From: Amanda Scholes on behalf of Planning.Responses
Sent: 05 February 2018 08:55
To: Planning Scanning
Subject: FW: Y/51/17/DOC - Yapton Free Church - 22815
Attachments: 201_A_Proposed Drainage Layout.pdf

PROJECT
Yapton Free Church,
Yapton

TITLE
Proposed Drainage
and Construction Details

PROJECT NO.
22815

FIGURE B.21
TYPICAL INSPECTION CHAMBER DETAIL - TYPE 4 (Flexible material detail)
Maximum depth from cover level to soffit of pipe 2 m, non-entry

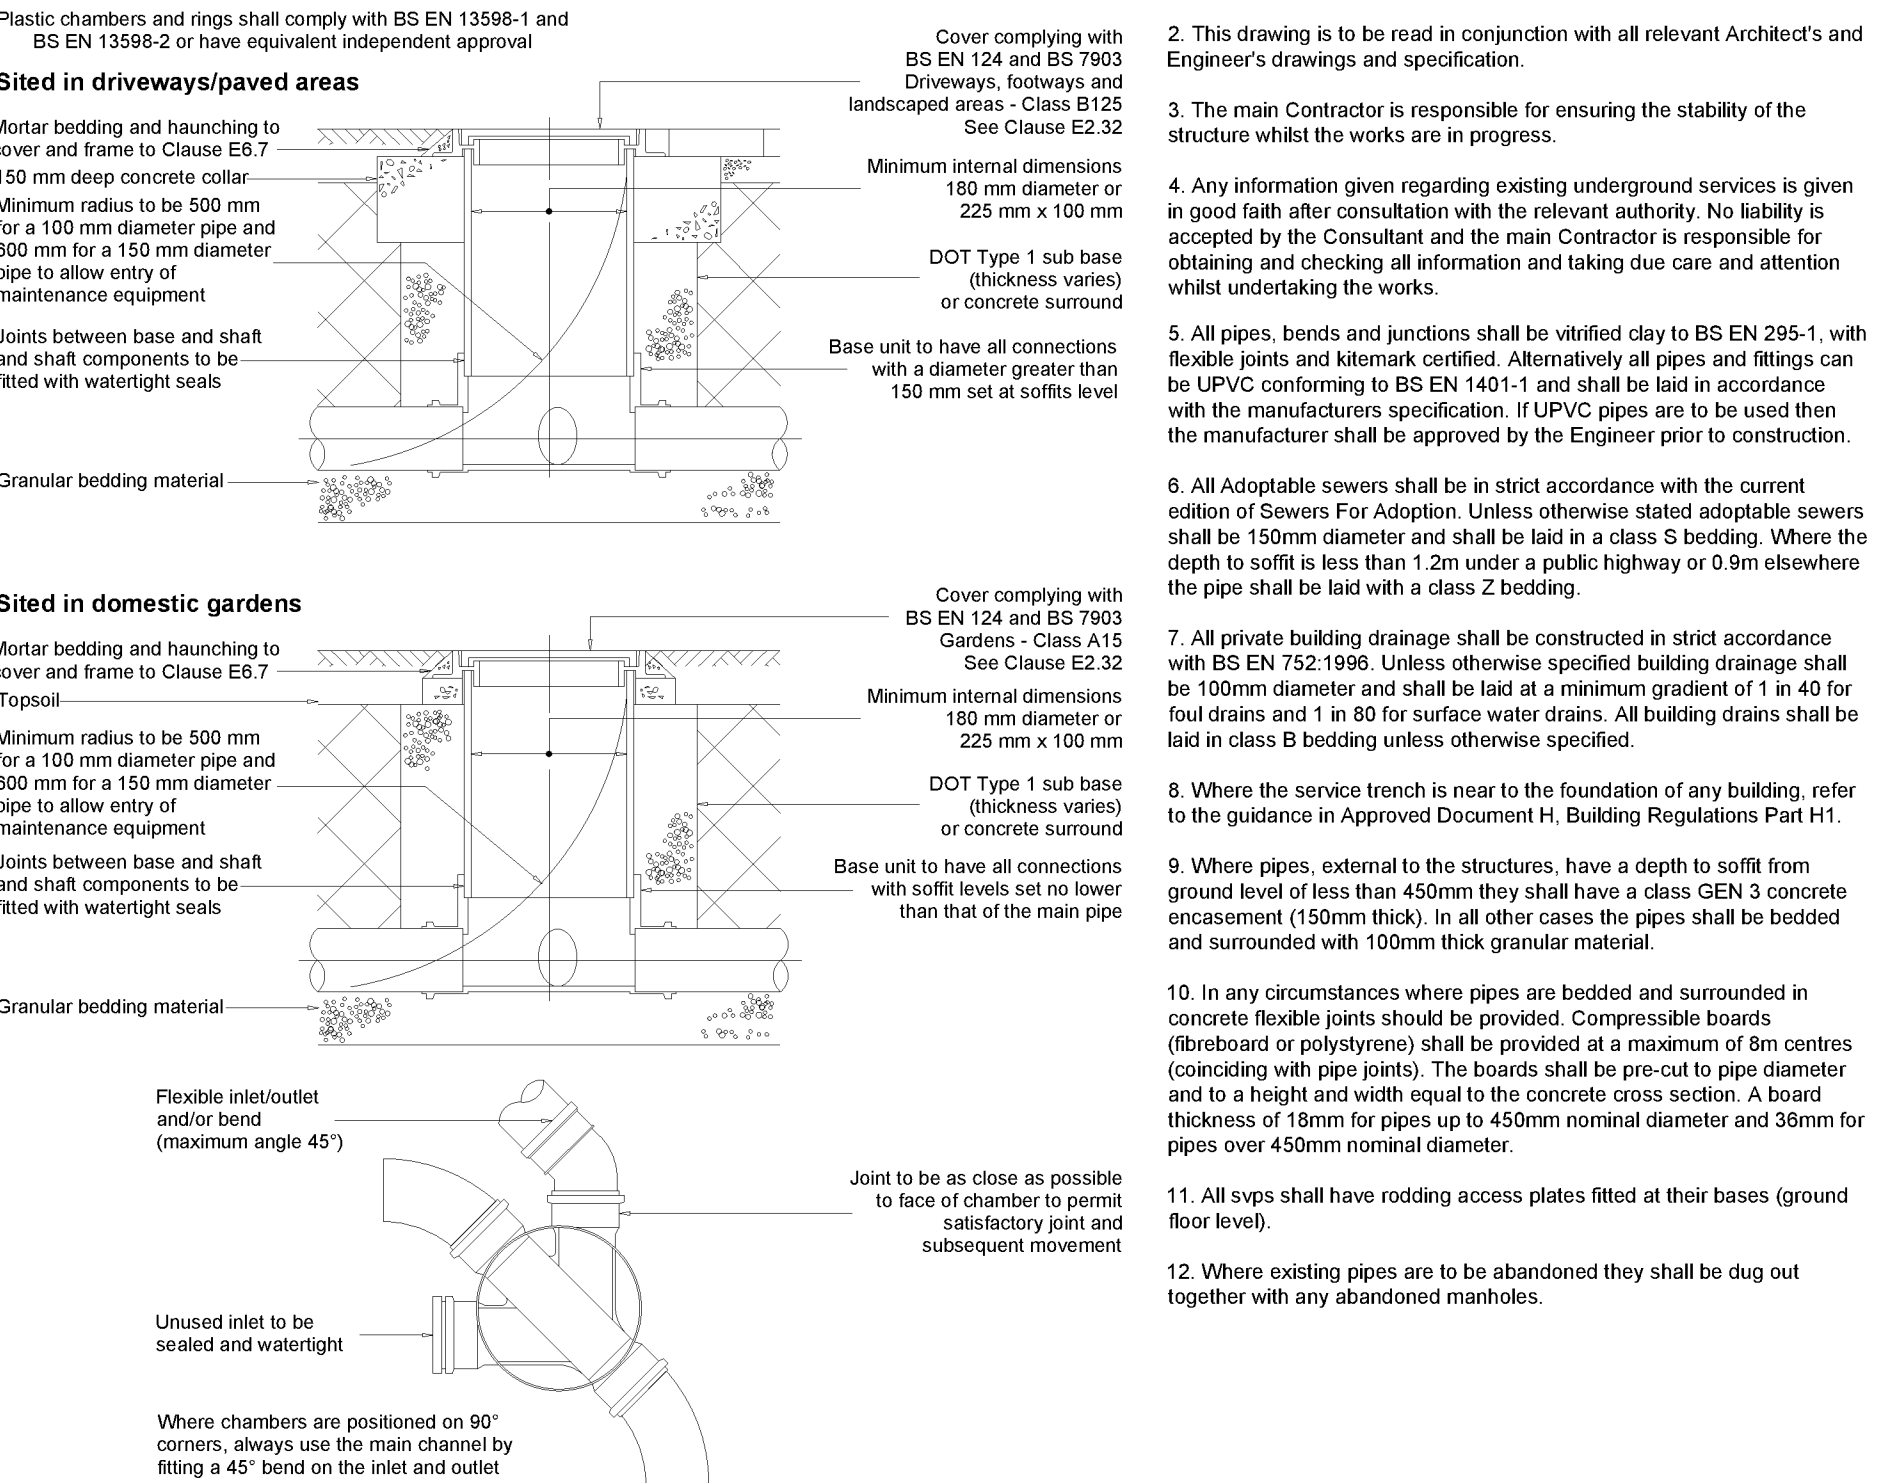
Condition can be discharged based upon the revised details, including drg no. 22815/201 Rev A, which I have enclosed.

Further to our telephone conversation regarding the percolation rate used for the calculations, please note that the percolation rate used is the same in both sets of calculations.

We have provided you with both Microdrainage calculation sheets and our internal spreadsheet extract demonstrating that the proposed system works.

Microdrainage method of inputting factor of safety is different as it requires one to be specified in the input separate to the percolation value.

Our simplified spreadsheet incorporates the factor of safety within the percolation rate hence the difference between the two printed versions.

Both sets of calculations demonstrate that the proposed drainage system (same size under both calculation sets) meet your requirements.

I now attach the revised MicroDrainage Calculation with the correct cover and invert levels together with the rainfall details as requested.

A 05.01.18 TZ Soakaway Size Revised SRM
